Interactive comment on “A geophone-based and low-cost data acquisition and analysis system designed to microtremor measurements” by Ozkan Kafadar

Ozkan Kafadar

Received and published: 15 July 2020

Fig. 9. The obtained H/V spectral ratios of recorded data by a) GeoBox b) MicDAC.

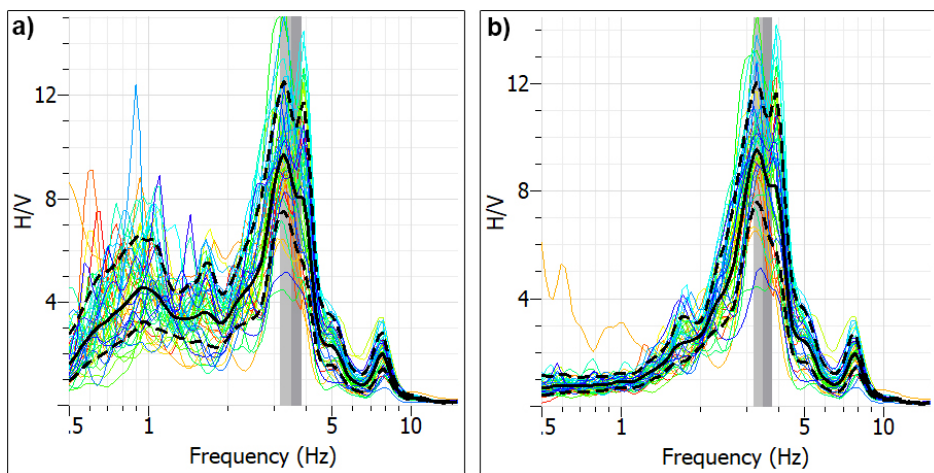
Comment 2: Figure 9: substitute “H/V spectrum ratios” with “H/V spectral ratios”.

Comment 3: Figure 9: there is a perfect match between H/V spectral ratios obtained from data recorded by GeoBox and MicDAC above 2 Hz. On the other hand, below 2 Hz the H/V functions significantly differ each other. Could you explain why? Is this difference due to the different quality of sensors for frequencies below 2 Hz? Please, justify this possibly with the help of an additional figure if necessary.

Reply 2: Thank you very much for your suggestion. I used the “spectral” term instead of the “spectrum”.

Figure 9. The obtained H/V **spectral** ratios of recorded data by a) GeoBox b) MicDAC.

Reply 3: Thank you very much for your suggestion. The reason of the difference at frequencies below 2 Hz is that the GeoBox uses an electronic circuit board to obtain a flat band wider than the natural band of the geophone and moves the eigen-frequency to lower value. In this way, it can obtain better sensitiviyy at lower frequencies. I briefly explained the reason of amplitude difference of H/V curves at frequencies below 2 Hz in the last paragraph of Section 3.3

Page 8, line 145: Finally, the MicDAC was compared with a triaxial digital seismograph

called as GeoBox manufactured by SARA Electronic Instruments. The GeoBox is an instrument designed especially for recording ambient seismic noise, and its different versions with sensors of 2 and 4.5 Hz are available in the market. In this study, the SR04HS model with 4.5 Hz sensors of GeoBox was used to make a comparison with MicDAC. The signals recorded simultaneously by MicDAC and GeoBox are shown in Fig. 8a and Fig. 8b. Log-MT software was used to monitor and to record the signals with GeoBox. Two different gain levels, 46 dB and 60 dB, were used in the signals recorded using MicDAC. As a result of this comparison in the time domain, a good correlation between the recorded signals using GeoBox and MicDAC was observed. This similarity was also observed in their frequency spectra (Fig. 8c). In addition to the comparisons in the time and frequency domains, their H/V spectral ratios were also obtained using the Geopsy software (Fig. 9a and 9b). The obtained H/V peak frequencies and amplitudes were given in Table 2. A good correlation was observed between the calculated H/V peak frequencies and amplitudes. **The main reason for the differences in the amplitudes of the H/V curves at frequencies below 2 Hz is related to the electronic design of the GeoBox. Since GeoBox has an electronic architecture that can obtain a flat band wider than the natural band of the geophone embedded in the instrument. Therefore, it obtains better sensitivity at low frequencies.**
